# **STRATEGIC ENVIRONMENTAL ASSESSMENT FOR A SECOND NUCLEAR POWER PLANT IN BORSSELE**

Expert Statement on the Draft Memorandum on  
Scope and Level of Detail

Developed on behalf of  
Bundesministerium für Land- und Forstwirtschaft,  
Umwelt und Wasserwirtschaft  
Abteilung V/6 Nuklearkoordination  
GZ BMLFUW-UW. 1.1.2/0003-V/6/2011

Figure 4: Sites that could be investigated for the nuclear plant and laydown area.

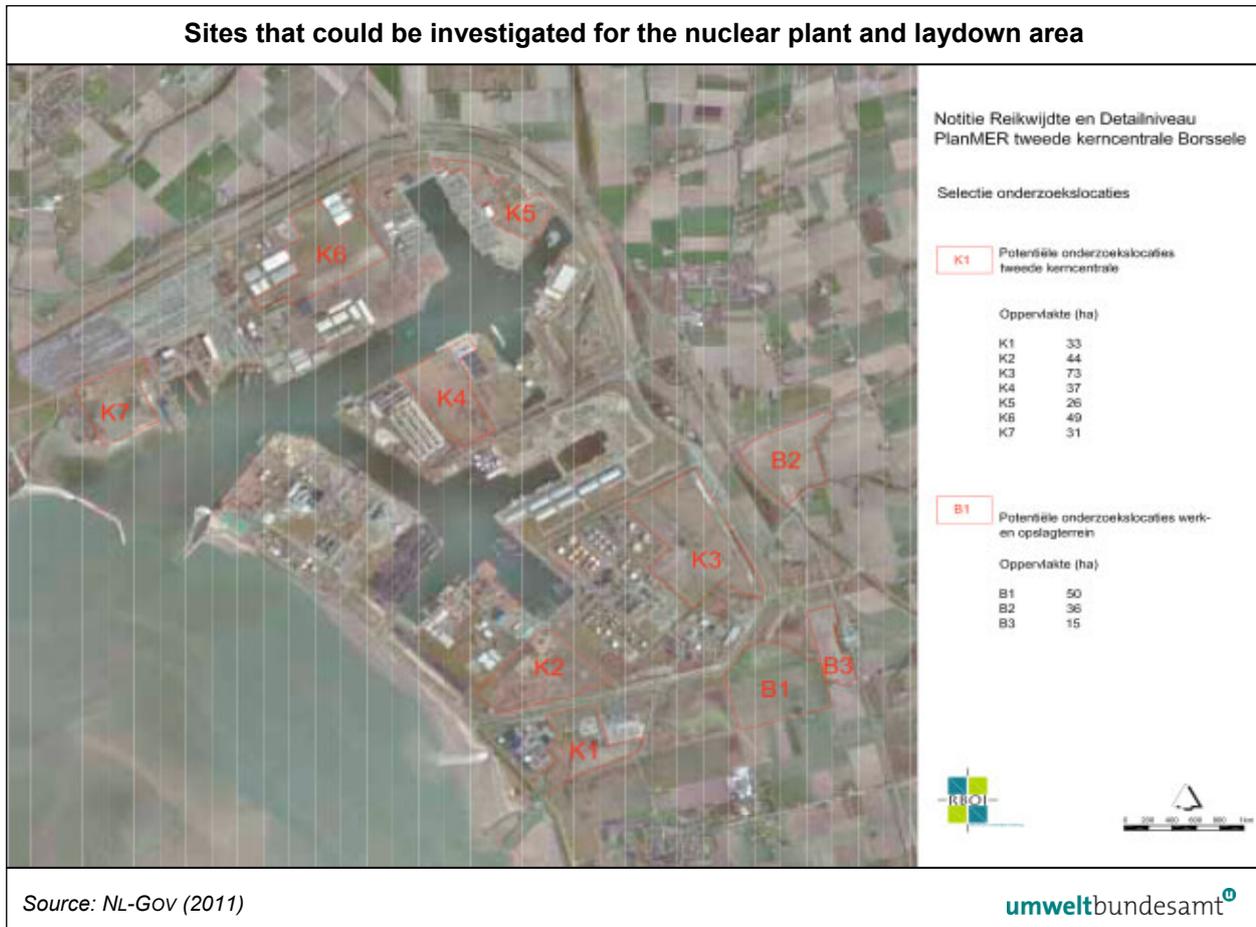
Out of the 7 sites only K5 is unsuitable for the NPP because of its layout.

K1, K2 and K7 are close to the mouth of the harbor and thus through-flow cooling is a realistic option. K3 and K6 will be investigated only if through-flow cooling proves impossible at the other sites. The first sites to be investigated are K1, K2, K4 and K7. (NL-Gov 2011)

Only sites K1 and K3 are situated within the Westerschelde dike. The other five sites are located outside the dikes.

Some sites are next to industrial complexes, which could pose explosion or fire hazards for the new NPP, such as the refinery adjoining K3 and other chemical enterprises, as well as the transport of chemicals in the neighborhood. A ranking of the considered sites according to the hazards mentioned would be an important piece of information.

Figure 5: Historical earthquakes in the Netherlands.

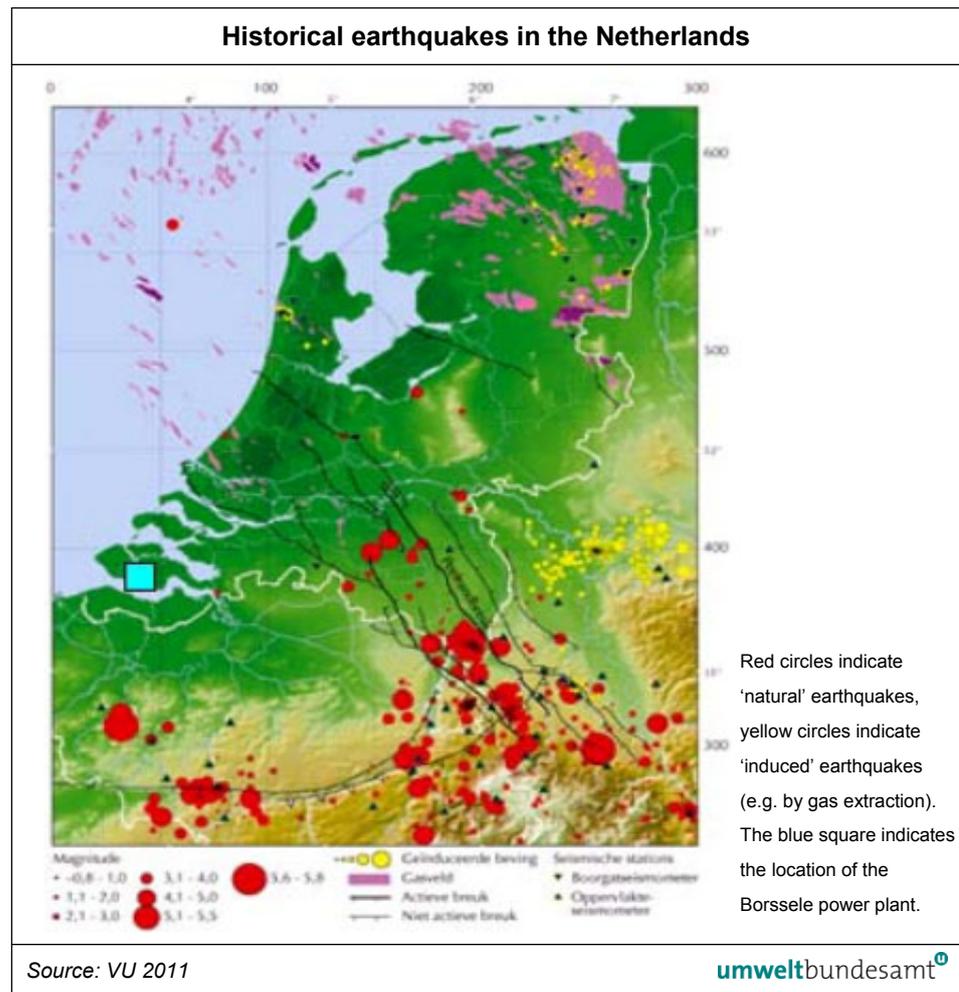
The preliminary memorandum of Delta and the Notification of ERH does not even mention the earthquake hazard. In general the region’s earthquake hazard is perceived as being small. The earthquake map below confirms this assumption. The largest recorded quake in the Netherlands occurred in Roermond in 1992 and measured 5.4 on the Richter scale; this corresponds to MSK 7 and in terms of peak horizontal acceleration (PGA) this is about 0.15 g. The region has a risk of an earthquake with a magnitude of 5 in the Richter scale of once in 500 years (PGA = 0.1 g). It is unlikely that such an earthquake would seriously damage a new NPP.

The site investigation needs to reassess the earthquake risk in the Sloe area with state of the art methods for a large area surrounding the potential NPP site.

In addition to the earthquake risk a geotechnical evaluation of each location assessing the stability of the geological set-up is very important for the base of the reactor building.
